Local Planning Panel

38-44 Mountain Street, Ultimo

D/2020/1288/A

S4.55(2) modification for alterations and additions to existing warehouse building including:

Issue - Height

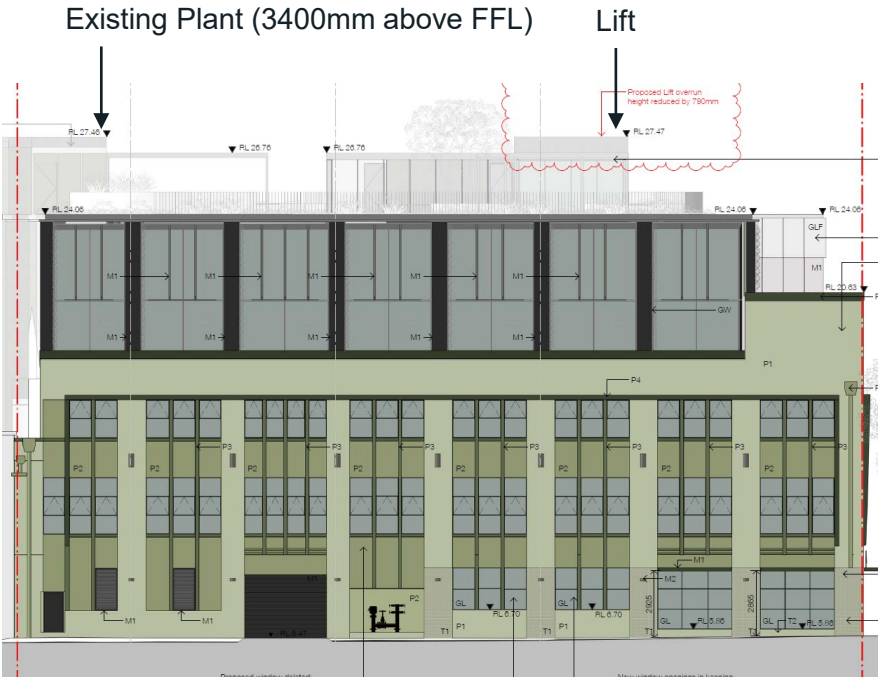
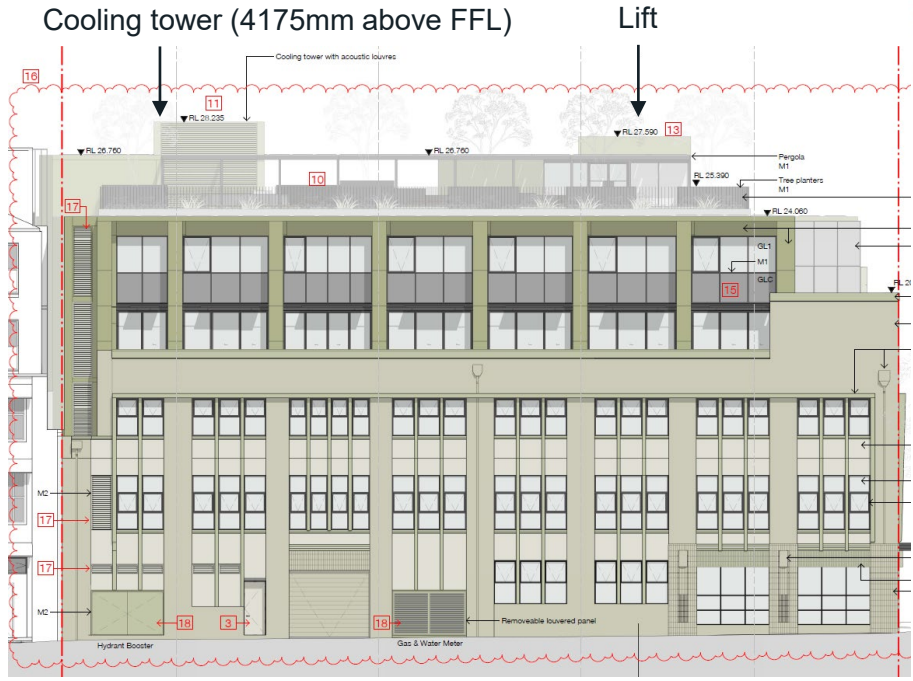
- cooling tower creates a total height exceedance of 25.1% against height standard (6.8% increase upon approved height)
- lift overrun proposed to be increased by 120mm for lift mechanism
- the cooling tower will enable compliance with a condition of consent regarding NABERs rating, and the height exceedances are not likely to generate any environmental impacts
